Dublin Airport North Runway

Addendum Report - Noise

0000-BHE-EN-NS-DF-0-EIAR

19 April 2024

Figure 14.1 – RSIGS Initial Eligibility Boundaries

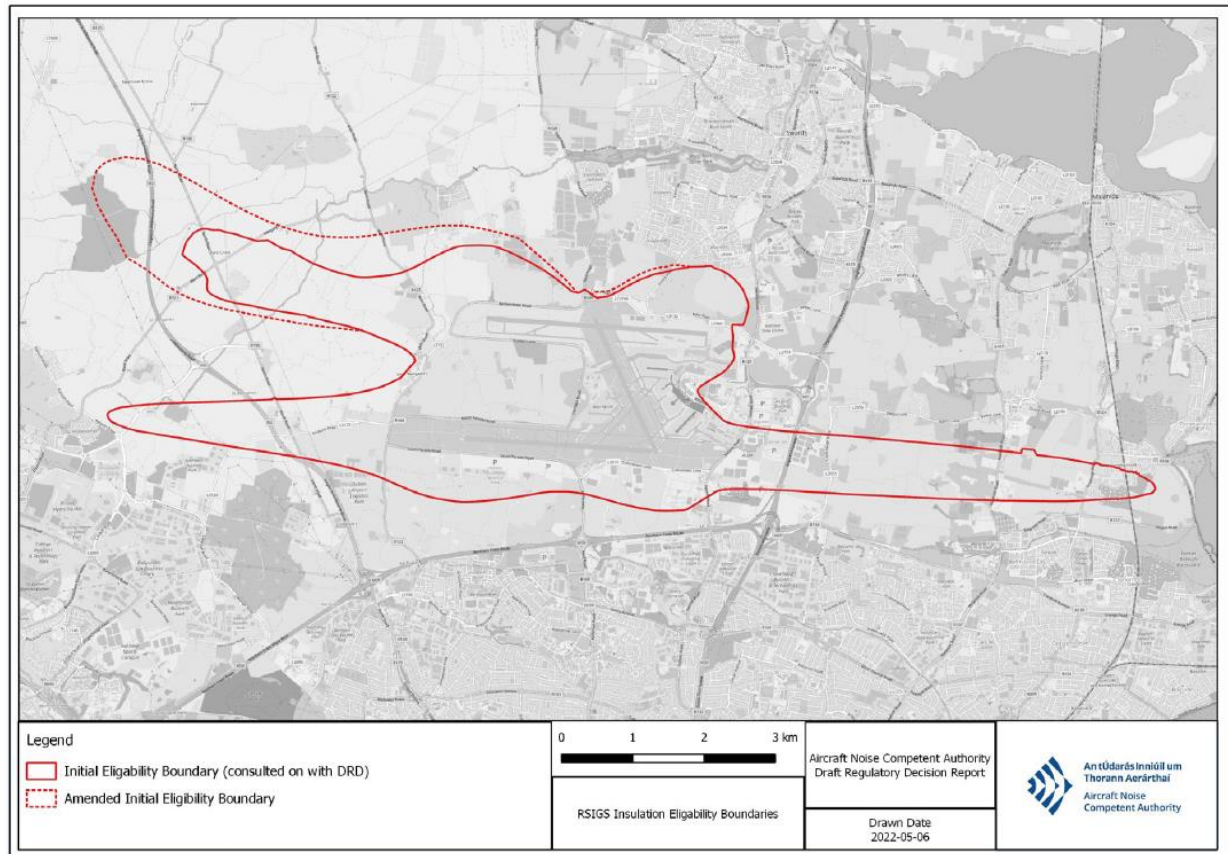
The initial Vanguardia report, and this report, supports the proposal to offer noise insulation to those who are not only exposed to a level of 55 dB L_{night}, but also those who experience a substantial change in noise at night of 9 decibels resulting in a minimum level of 50 dB L_{night}. It should be remembered that there are impacts on sleep at noise levels below the priority level of 55 L_{night}, albeit this level is a reasonable threshold of likely significant effect, and that relatively rapid increases in noise at night e.g. when a new runway comes into use or an existing runway starts to be used at night, can increase the numbers of persons experiencing sleep disturbance compared to a similar population exposed to the same noise levels for a relatively long time.

The scope and scale of the effect of the proposed second noise insulation criterion was illustrated by figure 14.1 of the RD report, as reproduced below.

Table 15: Overview map from the response to the 2ND RFI showing the initial noise insulation eligibility noise contour 2022 (pink) and the revised noise insulation eligibility noise contour 2023 (dark blue).

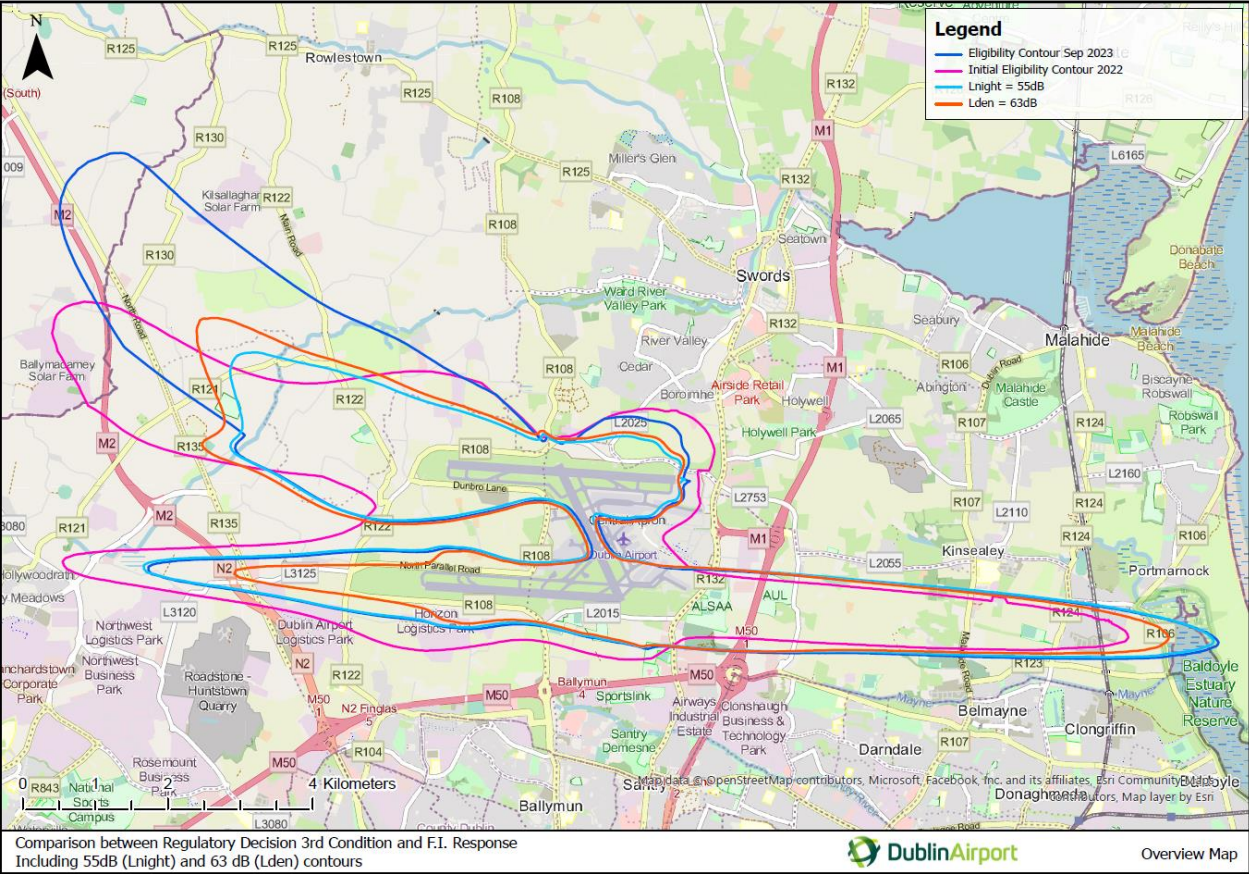
The second RFI by the board produced revised noise contours. These noise contours are different in size and shape to those presented previously. The letter accompanying the response to the second RFI discusses the differences as follows:

Since then, as described in the Applicant’s submission on 14th September 2023, the North runway has become operational which has allowed actual noise and track information from aircraft using it to be gathered and utilised when determining departure tracks, departure profiles and validating noise predictions. As such, given the previously predicted noise information has been revised, so too should the eligibility contour.

Other areas have demonstrated a reduction in the contour area, particularly to the west of both the north and south runways and the east of the north runway. The overall area of the eligibility contour increases from 28.5 km² for the contour based on the December 2021 submission, to 29.9 km² for the contour based on the September 2023 submission (an increase of approximately 5%). This is primarily due to the change in assumption regarding mixed mode operations, which had the effect of increasing the number of night flights assumed to use the North runway and therefore increasing the area assessed as having 'very significant' effects. The area of the 55 dB Lnight contour, which includes flights using both runways, remains almost identical, reducing from 20.8 km² in the December 2021 submission to 20.7 km² in the September 2023 submission.

The figure below is reproduced from the response to the Board's second RFI and illustrates how the Initial Eligibility September 2023 contour for noise insulation has changed from the Initial Eligibility Contour June 2022.
